WATER AND WASTEWATER BASIN OF DESIGN REPORT

CENTUM HOSPITAL SCOTTSDALE - 7331 E. OSBORN

CASE FILE 14-DR-2020_V2 - FINAL WATER AND WASTEWATER BOD REPORTS

CAROLLO ENGINEER'S CASE FILE REVIEW COMMENTS - 11/30/2020

WATER CAD LAYOUT
Kimley»Horn

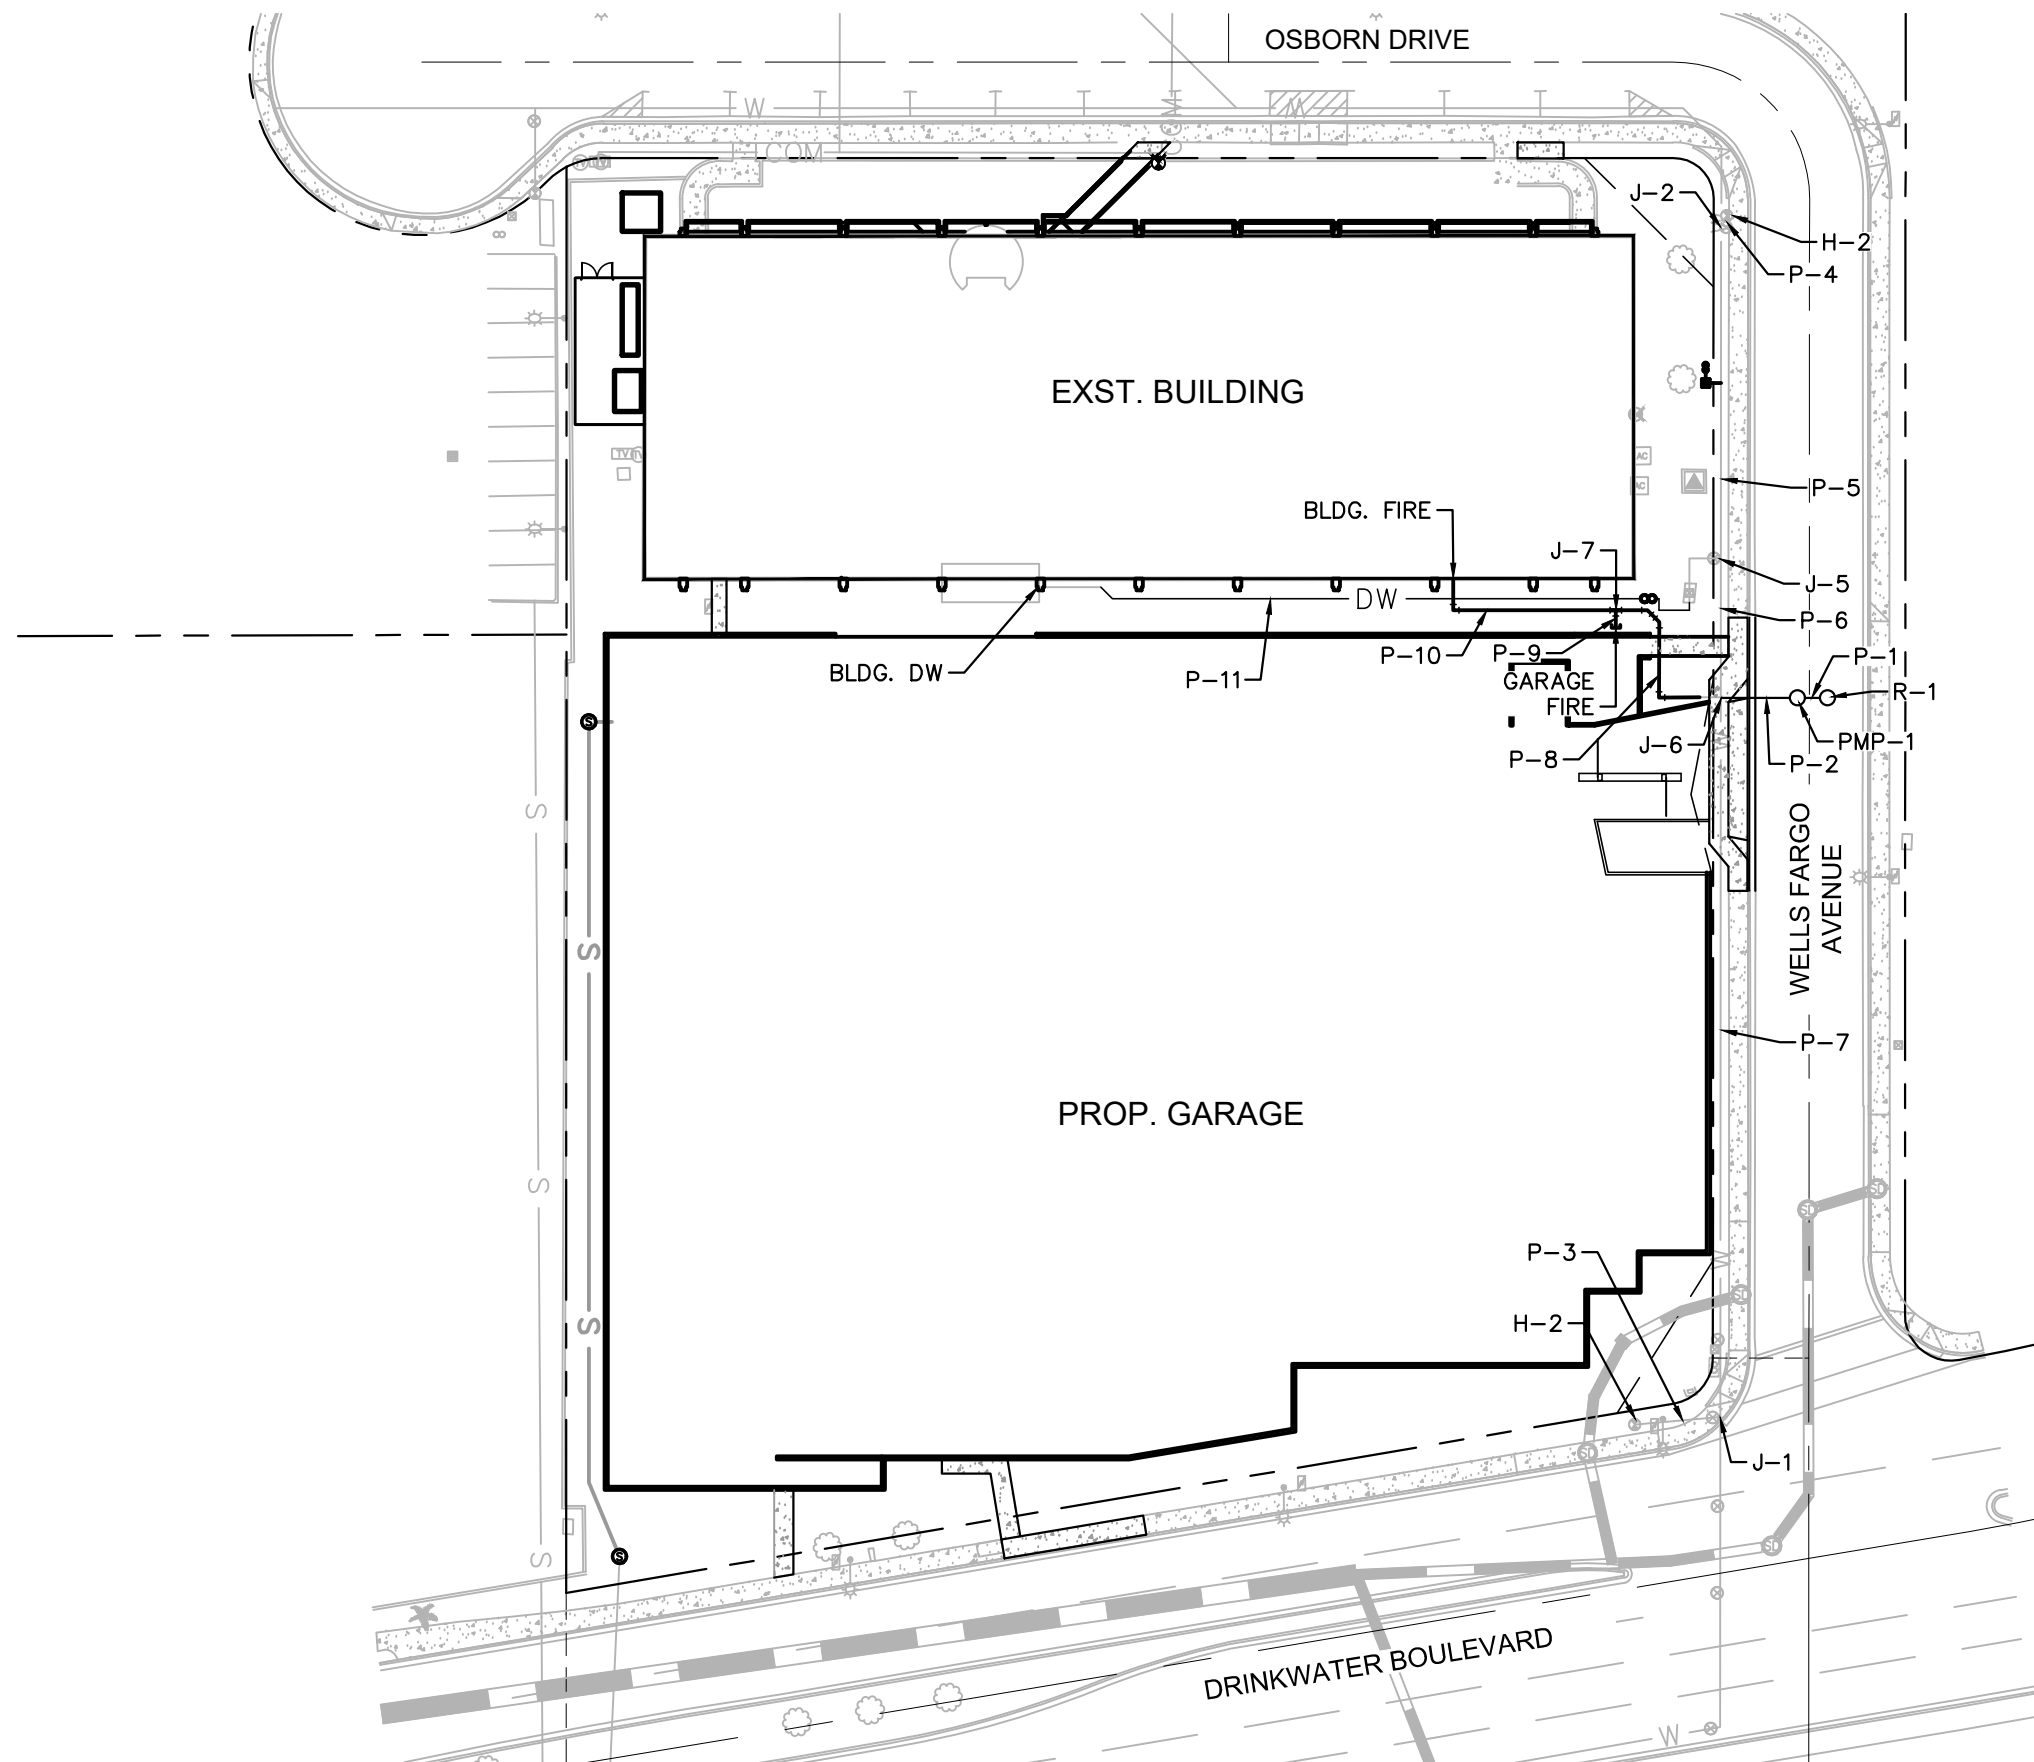
The system was analyzed for the worst-case scenario to ensure that the existing public water infrastructure can maintain a minimum pressure of 50 psi for the Peak Hour demand at highest Finish Floor Elevation of 1235.07 of the existing building, and 30 psi for the Maximum Day plus Fire Flow demand. See Appendix D for water model layout to identify nodes and pipes.

SEEMS TO BE
PEAK HOUR
+ FIRE FLOW?
ACCEPTABLE
BECAUSE PHD
IS > MDD
